Tennessee Valley Authority, Post Office Box 2000, Spring City, Tennessee 37381

WATTS BAR NUCLEAR PLANT (WBN) - RESPONSES TO ADDITIONAL NRC QUESTIONS ON  
CABLE TRAY CLASSIFICATION, CONDUIT DAMPING, AND FEEDWATER CHECK VALVE SLAM  
ANALYSIS (TAC NOS. R00508, 79717)

Enclosure 1

Enclosure 2

**Analysis Model  
Figure 2**

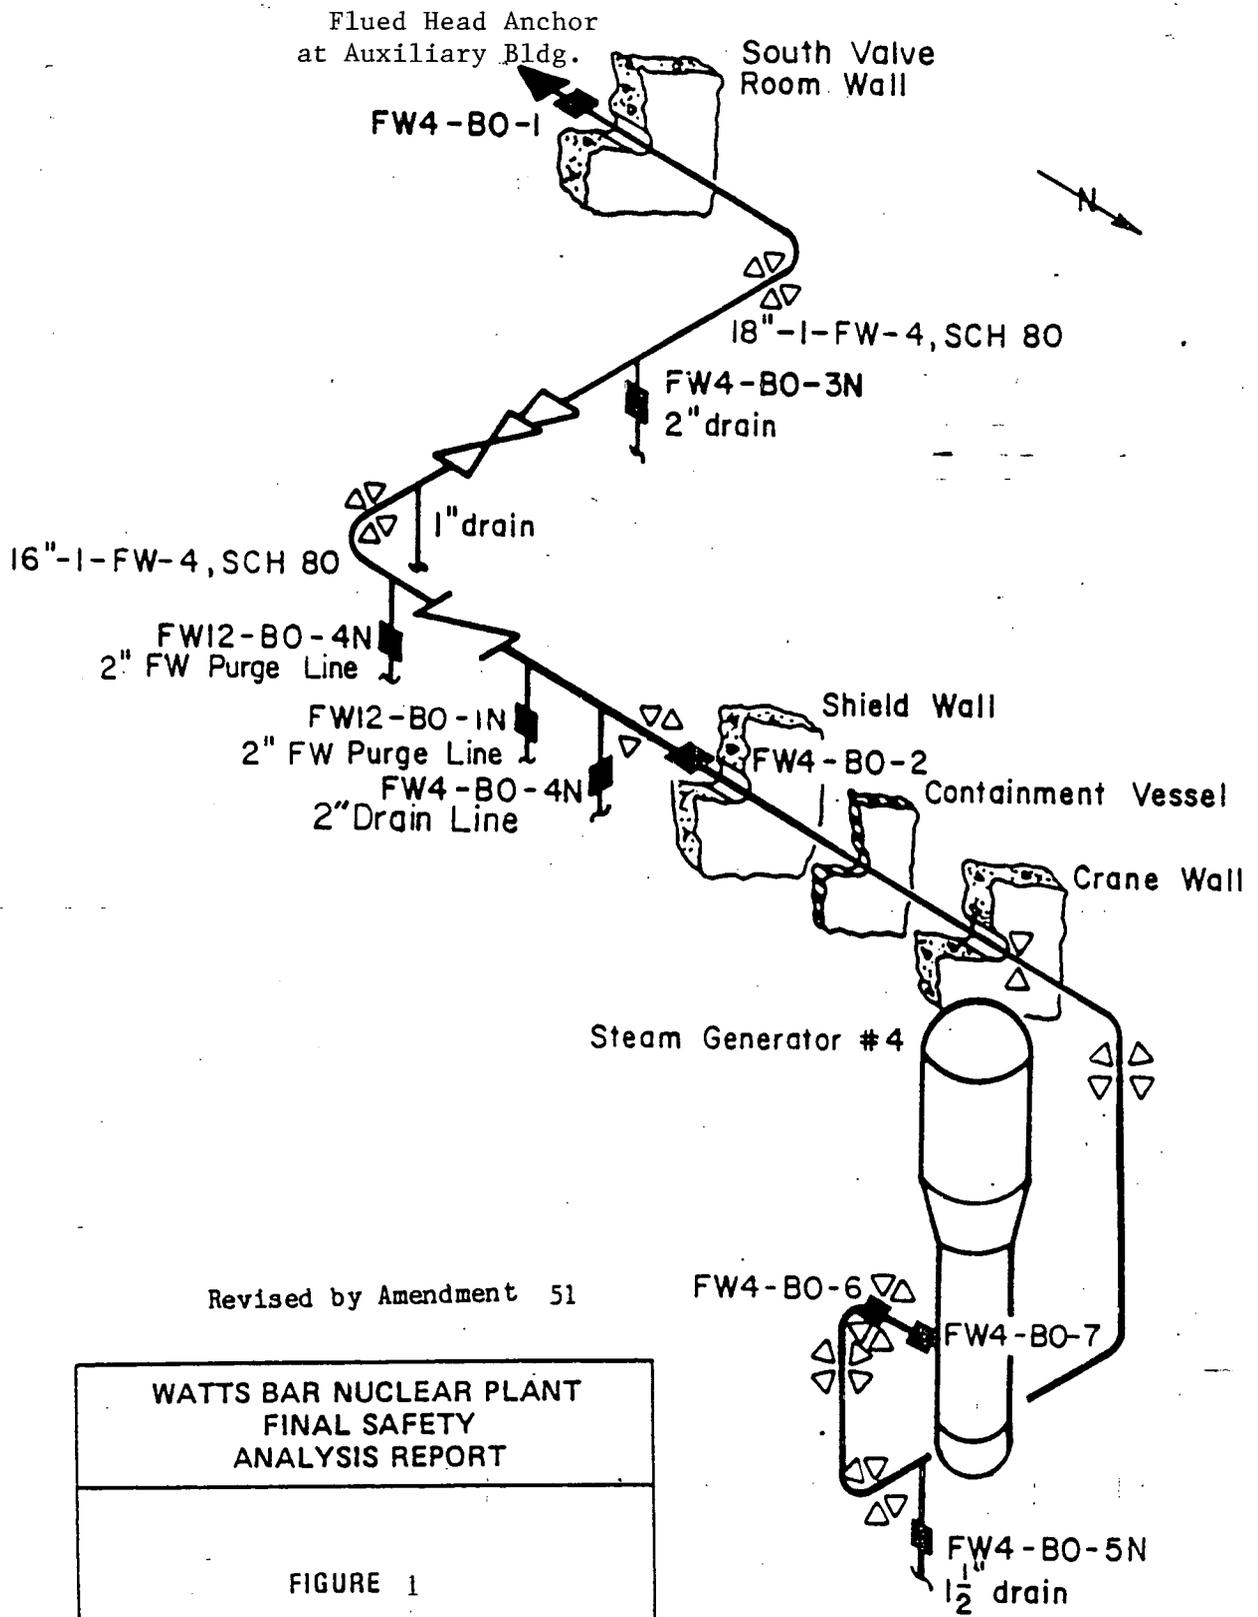
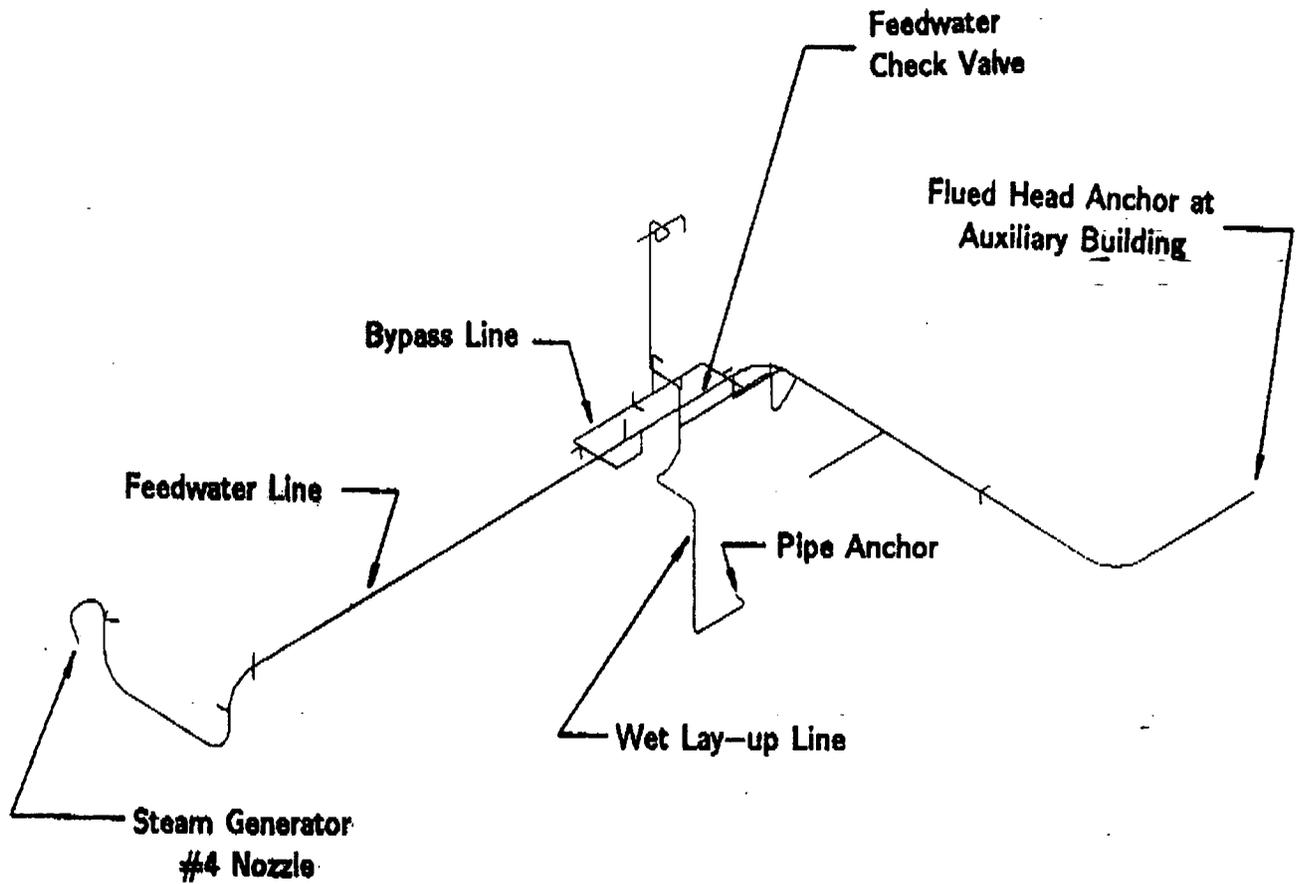
The stated methodology used is still an open issue.

TVA must present what was done for WBN on this subject.

Of the four feedwater lines at Watts Bar, the feedwater line associated with steam generator #4 was selected for analysis, having the maximum strains from initial transient analysis. The final analysis model includes the 16-inch feedwater line from the steam generator to the flued head anchor in the Auxiliary Building, the 2-inch bypass line around the check valve, and overlap portions of the 4-inch wet lay-up line to the isolation valve. (See Figures 1 and 2).

FIGURE 1

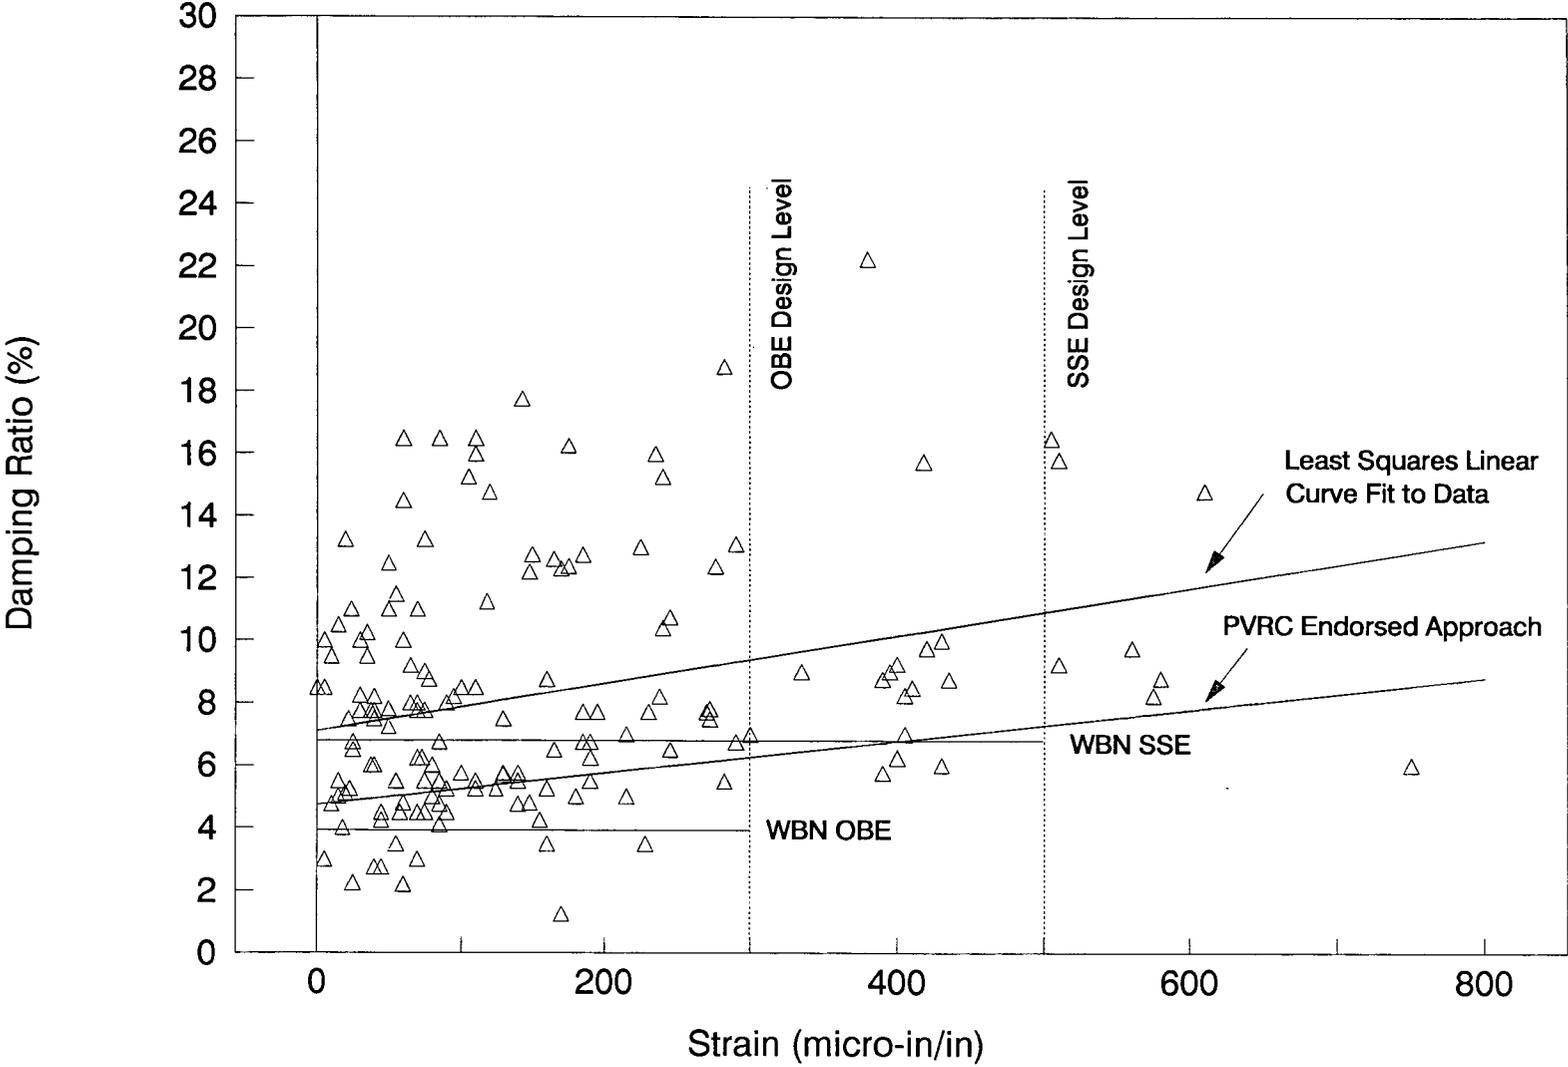
Table 3.7-2 is referenced for damping values. These values have been revised from old FSAR.

Numerous questions to be clarified by TVA. Basis for using average damping values needs justification. Tests by Wyle and ANCO correspond to lower values.

Applying this experimental option to the TVA Laboratory test data (Reference 1) gives 6.3% for OBE stress levels and 7.3% for SSE stress levels. The data evaluation procedure which supports these values is as follows:

1. Examine the steel conduit damping data when plotted as a function of frequency. This shows no frequency dependence (see Figure 11 of Reference 1).
2. Perform a least square linear fit to all steel conduit damping (y) data as a function of strain (x). This gives the equation  $y = 0.00763x + 7.1$ .

3. Define OBE and SSE levels at design allowable stresses of 8,700 psi and 14,500 psi respectively.
4. Divide these design allowable values by a typical value of modulus of elasticity of  $29 \times 10^6$  psi to obtain OBE and SSE strain thresholds.

5. Substitute OBE and SSE strain thresholds from (4) into the damping vs strain equation from (2). This gives 9.4% for OBE and 10.9% for SSE.
6. Multiply the experimentally determined damping values from (5) by 2/3 to give the allowable damping value for analysis purposes. This gives 6.3% for OBE and 7.3% for SSE. These values are greater than the 4% for OBE and 7% for SSE specified for WBN conduit qualifications.

A plot of the least square linear fit curve in relation to all steel conduit data from the TVA test program is shown in Figure 1. Damping values that would be endorsed using the PVRC approach are also shown in relation to the values specified for WBN.

Figure A

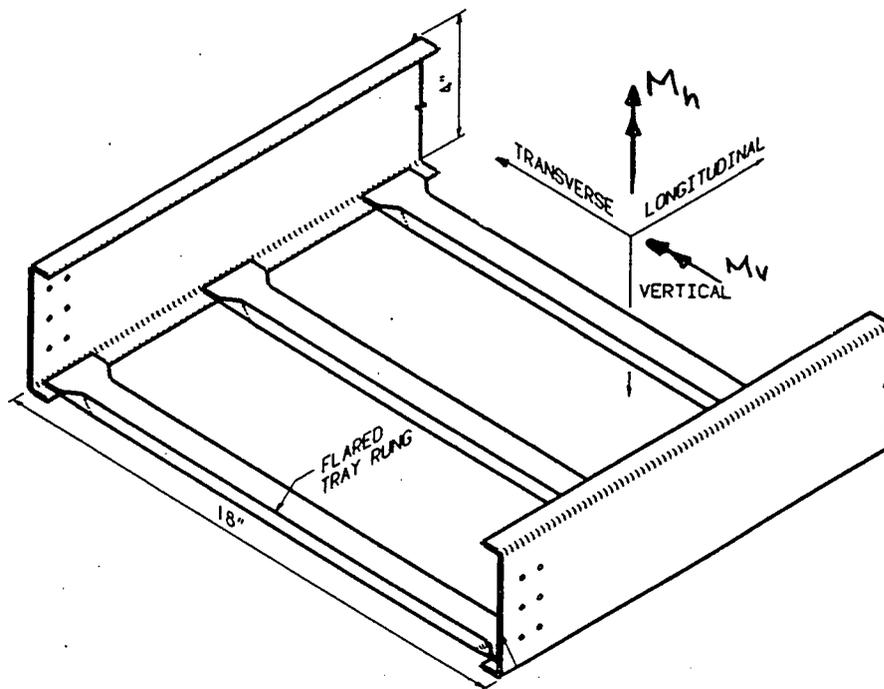
1. What tests were utilized to derive the allowable horizontal (transverse) and vertical moments,  $M_{ha}$  and  $M_{va}$ , respectively?

$M_{ha}$  was derived utilizing data from tests documented in References 1, 2, and 3. Tray hardware in these tests was of the type installed at Watts Bar Nuclear Plant (WBN). Tests in References 1 and 2 demonstrate that straight tray sections have inelastic transverse deformation capability far exceeding a ductility of three. The numeric value for  $M_{ha}$  was derived utilizing data from the test of Reference 3 in which a simply supported 8-foot tray span was loaded in the transverse direction. In this test no vertical load was applied and the bending moment could be readily calculated for a simple span. The load was increased until, the tray hold down clips developed significant deformation and the test was halted. The tray showed no sign of failure or excessive deformation under this load. (The type of light gage hold-down clips that secured the tray in this test are no longer utilized for WBN cable tray to support connections. Stronger connection clips made of structural steel and welded to the support members have replaced the original arrangement.)

$M_{va}$  was derived utilizing data from the test documented in Reference 4. In this test, a simply supported 8-foot span of tray of the type used at WBN was loaded in the vertical direction, with no transverse load applied.

See Figure A (sheet 2) for clarification and definition of the transverse and vertical moments.

$M_h$  is the bending moment due to loads in the transverse direction.

$M_v$  is the bending moment due to loads in the vertical direction (out of the plane of the tray).

# FIGURE 1. Allowable Transverse Moment and Vertical Moment Interaction

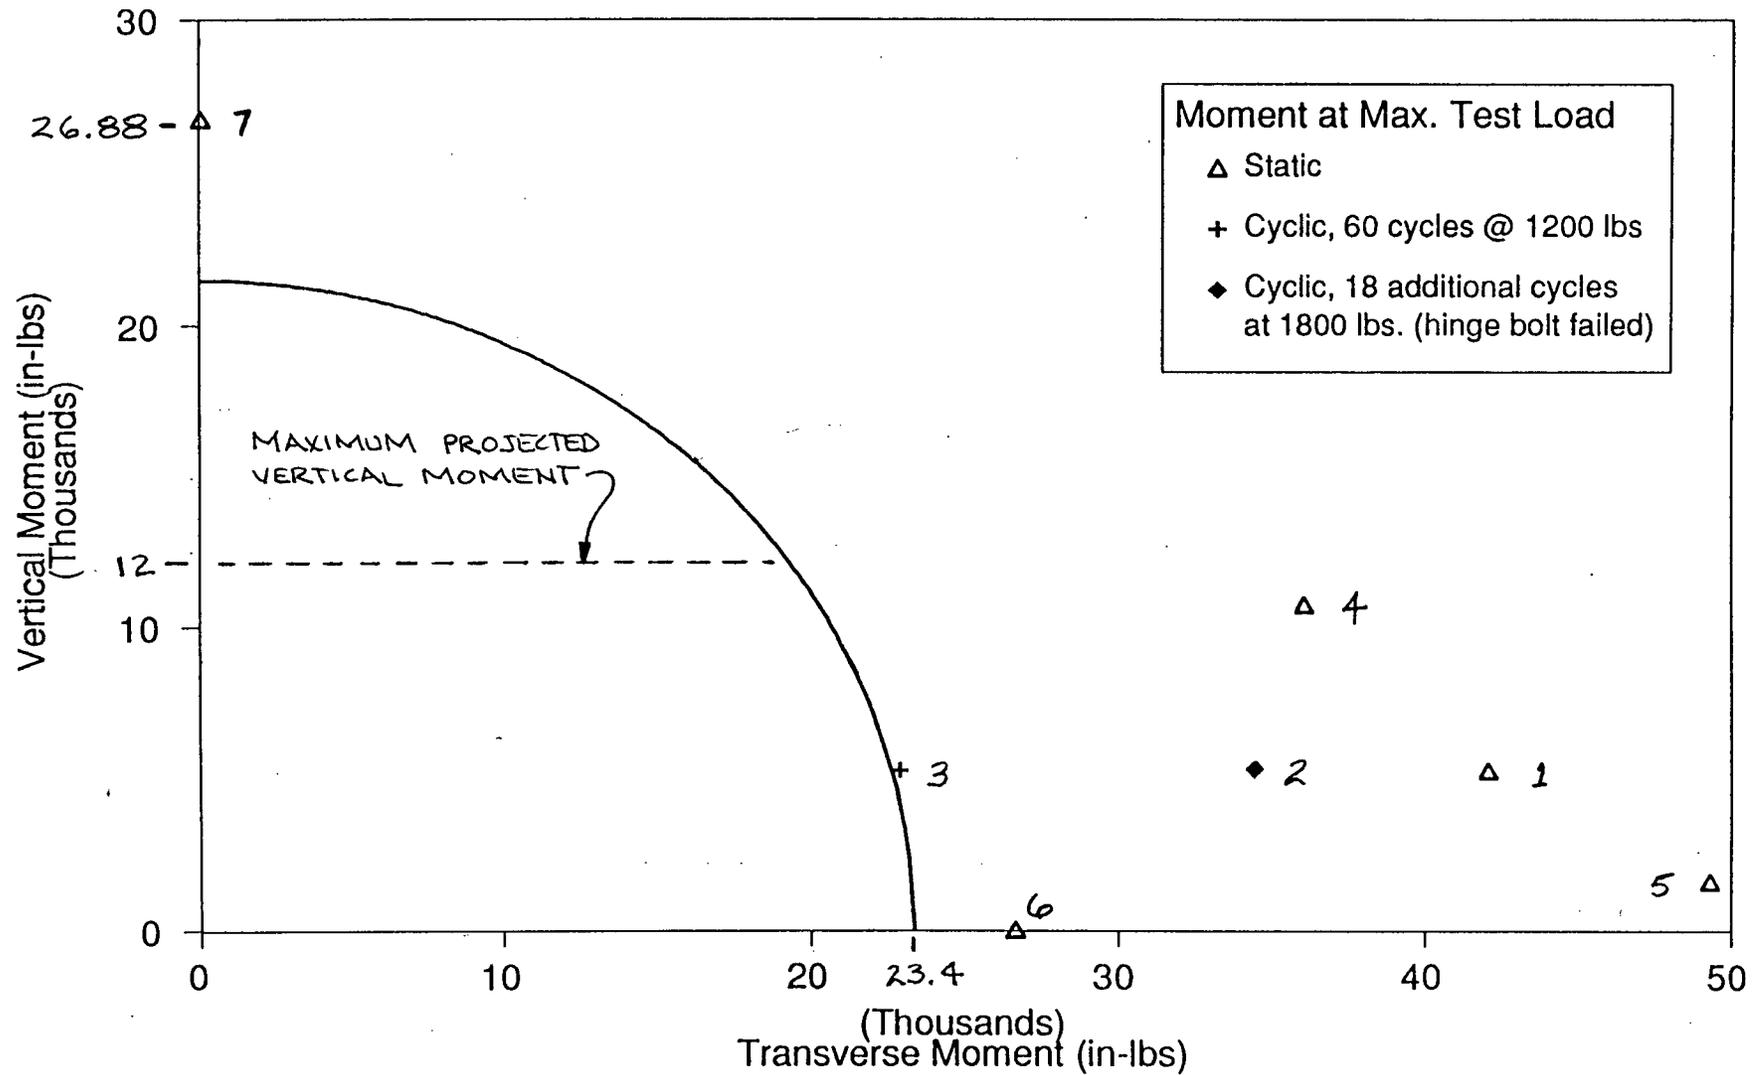
2. Basis for data points plotted in Figure 1?

3. How is the moment-interaction equation validated for bi-axial bending for cases with high vertical moment, cases for which test data is lacking?

The following table provides references for each of the test data points shown in Figure 1.

<u>Point</u>	<u>Reference#</u>	<u>Load</u> Transverse/Vertical (total lbs/ lbs/ft)
1	1, Table 1	2199/70 static
2	1, Table 2	1800/70 cyclic transverse
3	1, Table 2	1200/70 cyclic transverse
4	2, Table 1	1885/140 static
5	2, Table 2	2827/70 static
6	3, Page 1	1470/0 static
7	4, Page 1	0/280 static

1. Point 3 corresponds to 60 cycles at 1200 pounds (push/pull) of transverse load (no failure), after which the load was increased to 1800 pounds, shown as point 2 and cycled for 18 additional times.
2. At points 1 and 2, riser connector hinge bolt failed. At points 4, 5, and 7 significant flexural deformations developed in the siderail at the loads given. At point 6, vendor-supplied tray hold-down clips yielded (new structural angle connector now implemented) and test was stopped; the tray did not fail.

Based on a review and screening of cable tray routings in the plant, the highest vertical moment expected to occur in combination with horizontal moments is approximately 12,000-inch-pound (Figure 1).

Based on the margins available between this value of vertical moment (12,000-inch-pound) and the maximum value reached in the tests (26,880-inch-pound), and the demonstrated ductile behavior of tested cases with significant horizontal moment at similar vertical moment capacity (for example test point number 4), we concluded that the present interaction equation for the expected level of vertical moment is acceptable.
